Access Compliance Report

Public Rights-of-Way

(Curb Ramps)

Intersection ID: 2913	Main Street: CREEK_BREEZE_RD	Cross Street: MEADOWVIEW_HILLS_DR	Location: NW
ADA ID: 2C4AE7C10288	Ramp Type: PerpDiag	Initial Pass/Fail: Fail	Overall Compliance: No
Severity Score: 13.75			
Codes/Mitigation Info/Possible Solution		Field Measurements/Component Compliance

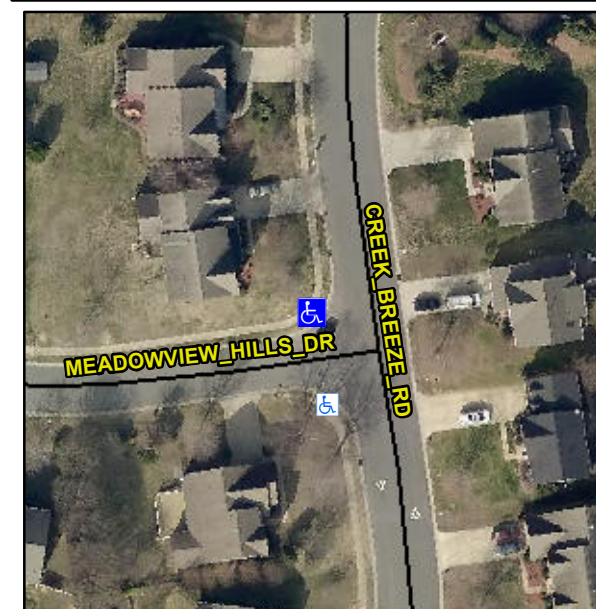
Not Found, R304.2.2, R304.5.3

Compliance	Description	Data	Compliance	Description	Data
N/A	Ramp Length (in)	46.0	No	Ramp Slope (%)	10.5
Yes	Ramp Width (in)	52.0	No	Ramp XSlope (%)	5.0
N/A	Flare Type LT	N/A	N/A	Flare Type RT	N/A
N/A	Flare Slope LT (%)	N/A	N/A	Flare Slope RT (%)	N/A
N/A	Flare Traversable LT?	N/A	N/A	Flare Traversable RT?	N/A
N/A	Landing Length (in)	N/A	N/A	DWS Provided?	N/A
N/A	Landing Width (in)	N/A	N/A	DWS Contrast?	N/A
N/A	Landing Slope (%)	N/A	N/A	DWS Length (in)	N/A
N/A	Landing X Slope (%)	N/A	N/A	DWS Full Width?	N/A
N/A	Landing Curb? (Y/N)	N/A	N/A	DWS Offset (in)	N/A
N/A	Shared Landing?	N/A			
N/A	Gutter Ponding?	N/A	N/A	Gutter Slope (%)	N/A
N/A	Gutter Lip Ht (in)	N/A	N/A	Gutter X Slope (%)	N/A
N/A	Painted X Walk1?	No	N/A	Painted X Walk2?	No
	X Walk 1 Direction	To E		X Walk 2 Direction	To S
N/A	X Walk 1 Width (in)	N/A	N/A	X Walk 2 Width (in)	N/A
	X Walk 1 Slope (%)	2.3		X Walk 2 Slope (%)	3.1
	X Walk 1 X Slope (%)	1.5		X Walk 2 X Slope (%)	4.6

Remove & Replace Curb Ramp With Two New Directional Ramps or Equivalent.
